# DEVELOPMENT REVIEW BOARD REPORT

**Mountain View  
Shopping Center -  
Exterior Remodel  
22-DR-2023**

Request for approval of exterior building modifications to an existing shopping center, including the removal of the existing arcade and changes to roofing material and paint for a +/- 7.6-acre site.

C:\Users\stewart\OneDrive\Documents\22097 Mountain View Plaza\Mountain View Plaza Construction Documents - B24 - exterior\B24.dwg

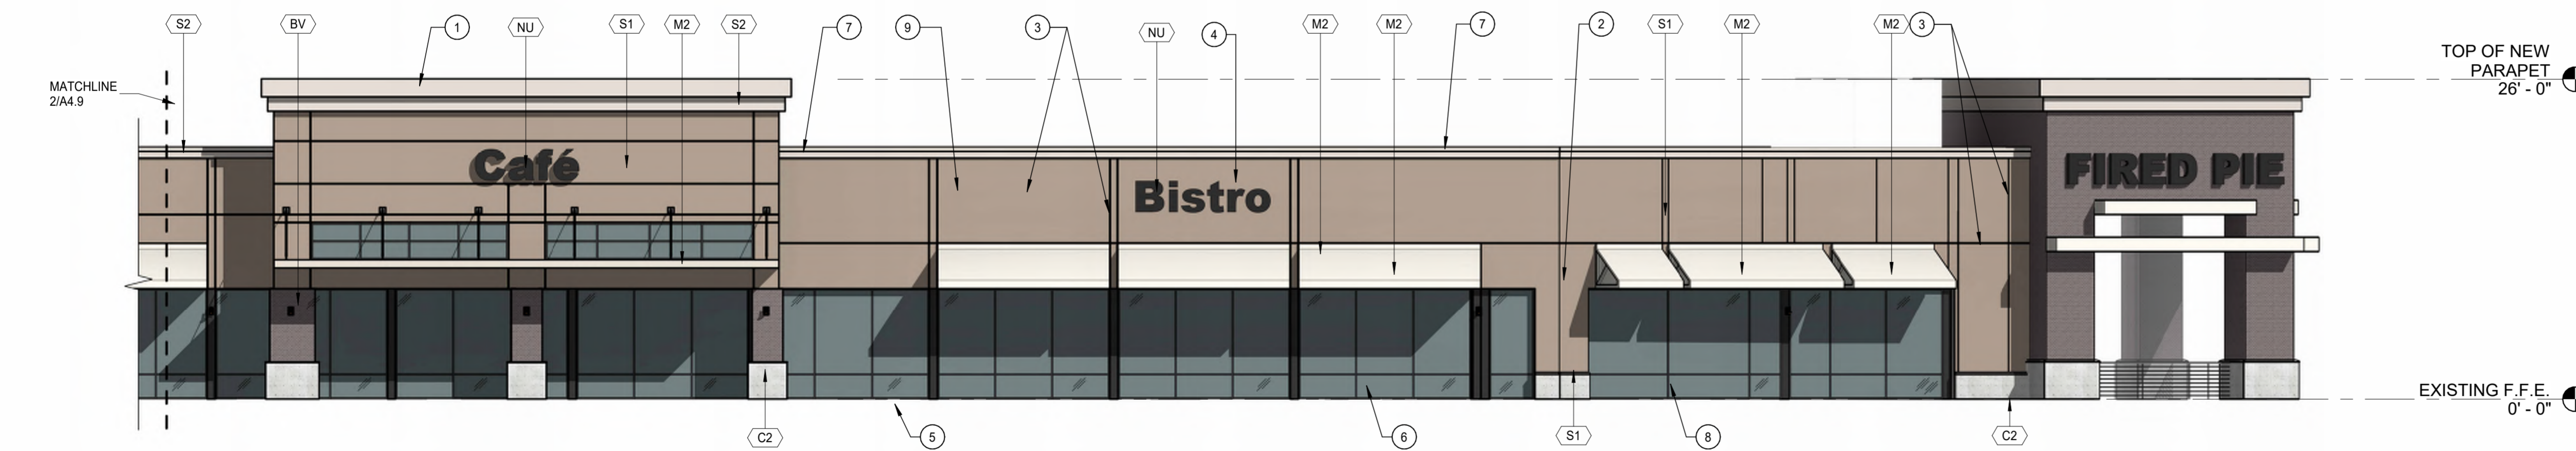
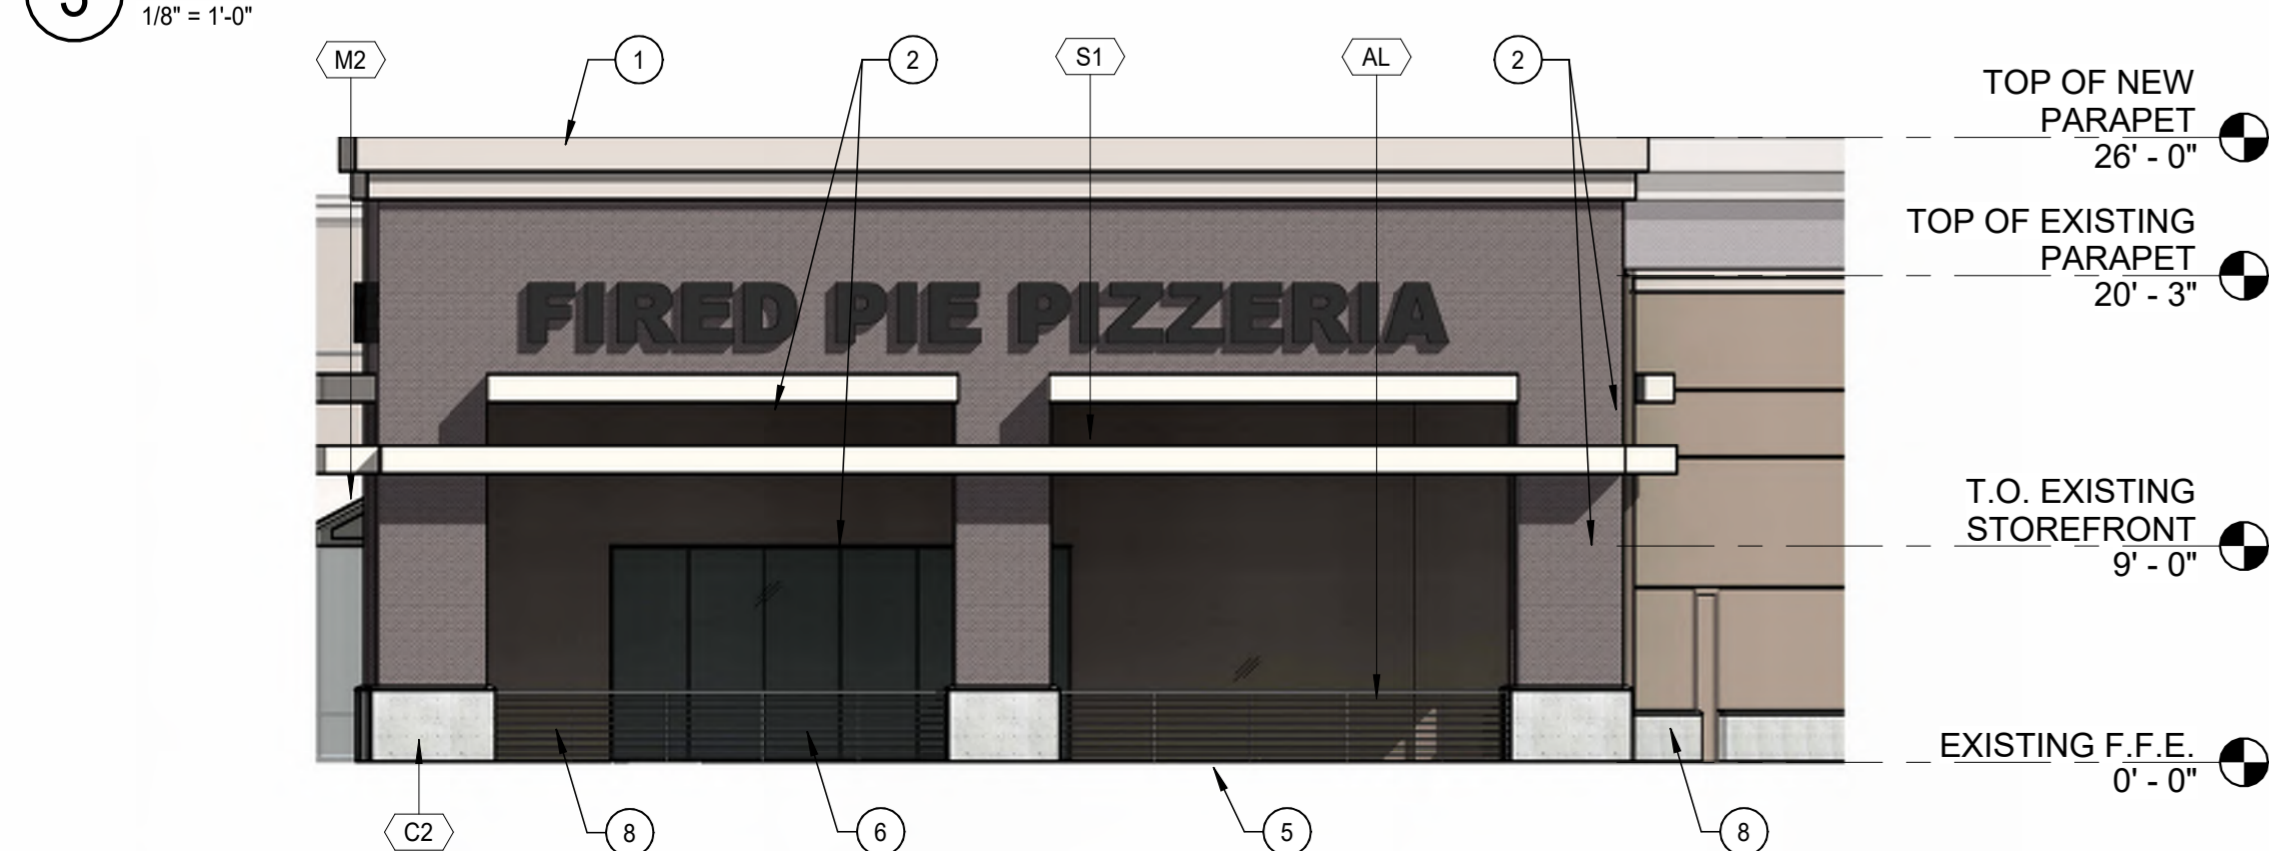
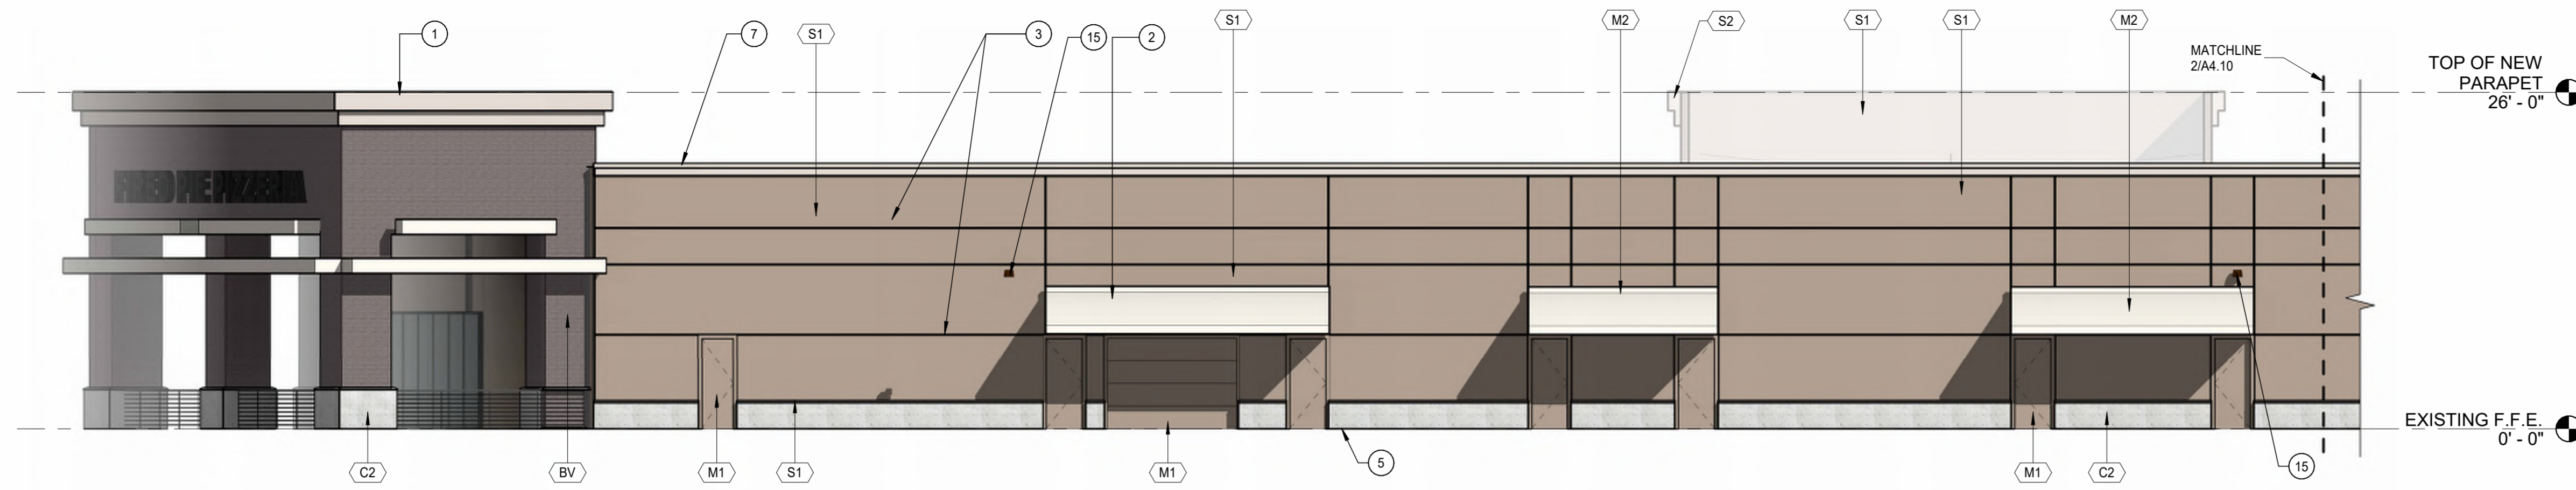
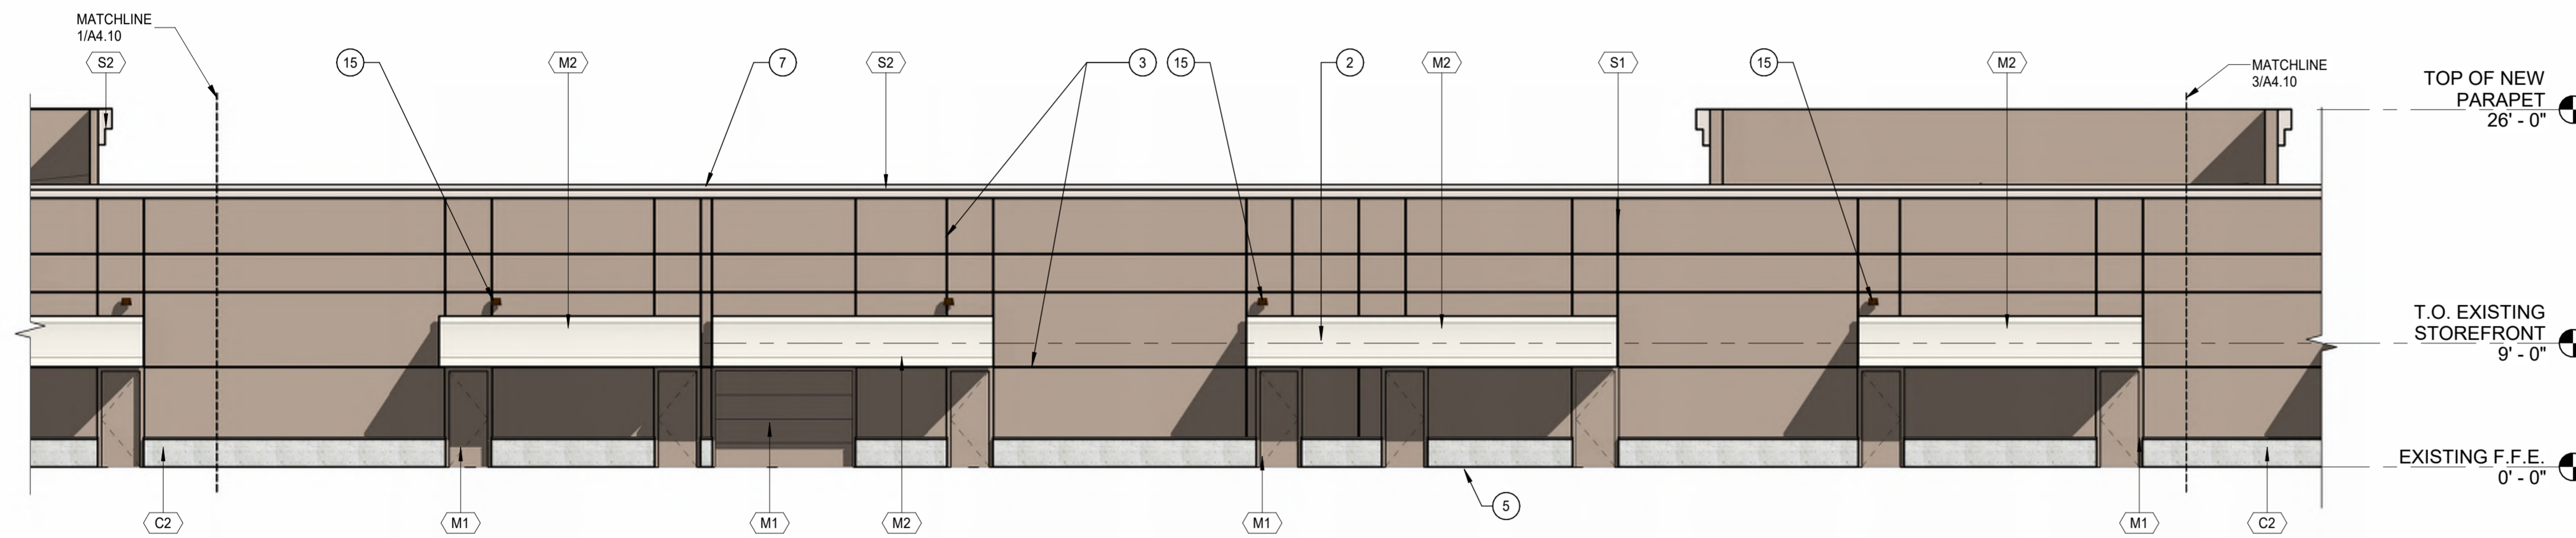
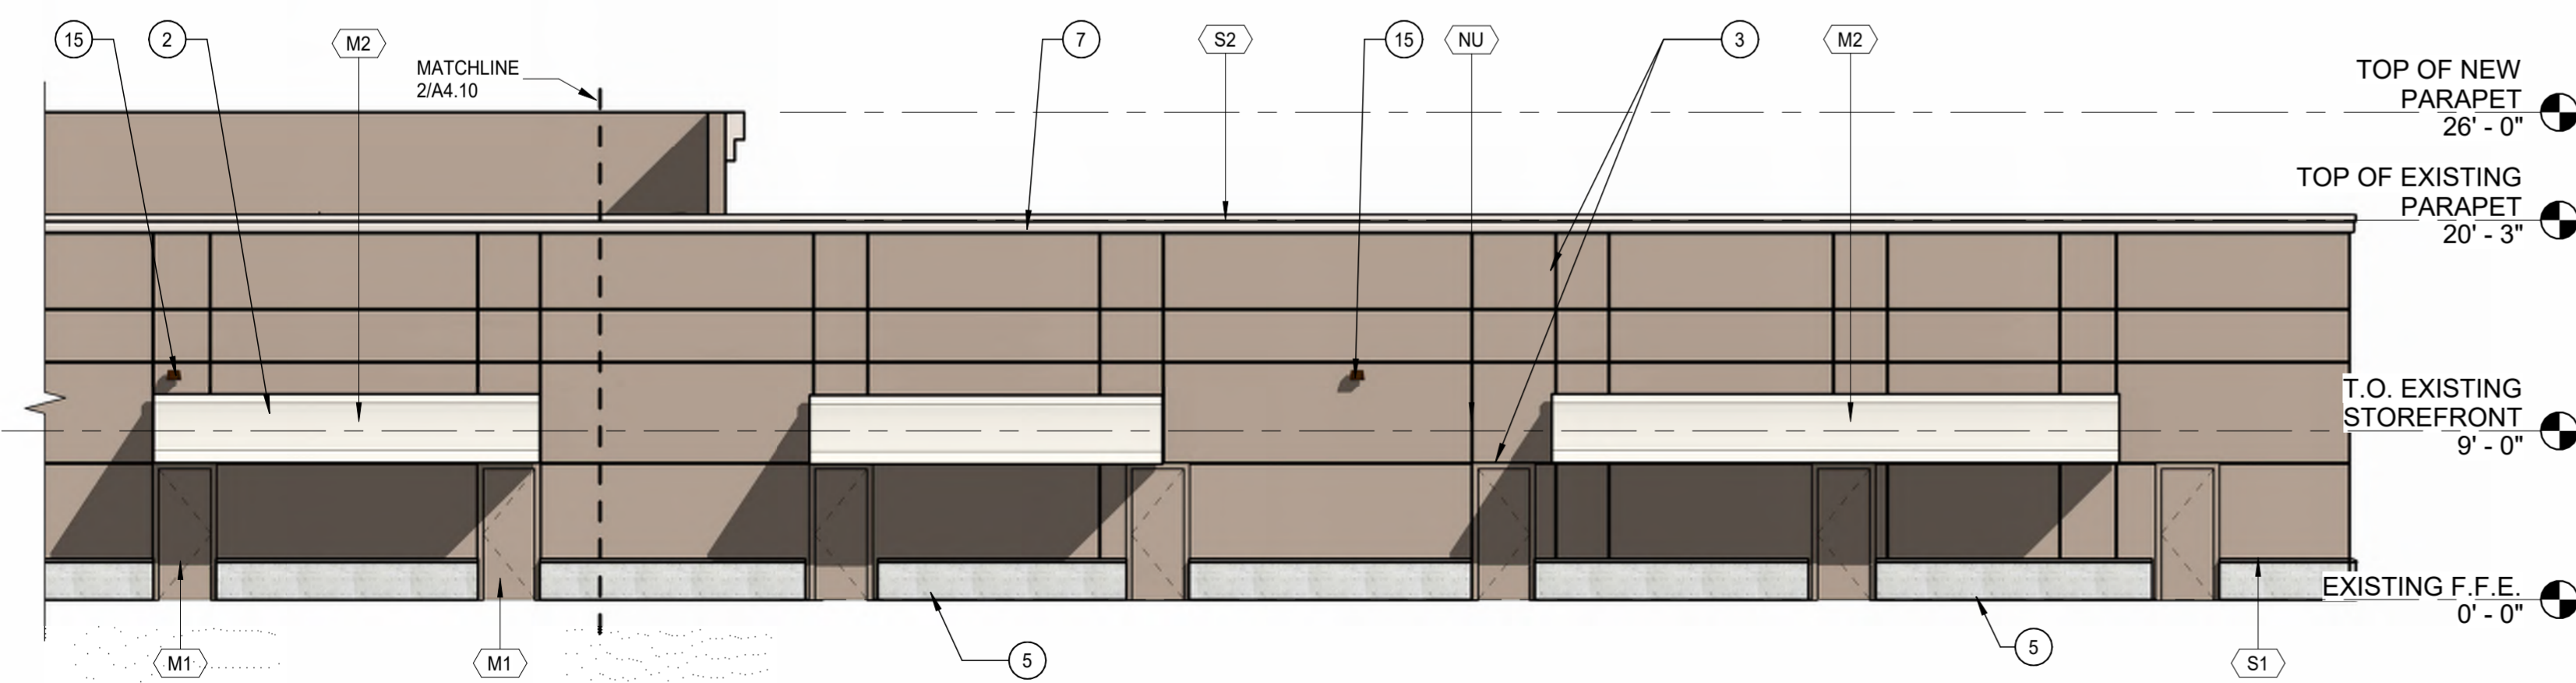
6. The concrete wainscot shall be extended to completely wrap all columns.
7. At time of final plans, the applicant shall submit updated elevations of all building facades to updated call out C2 as it does not exist. It should be C1.
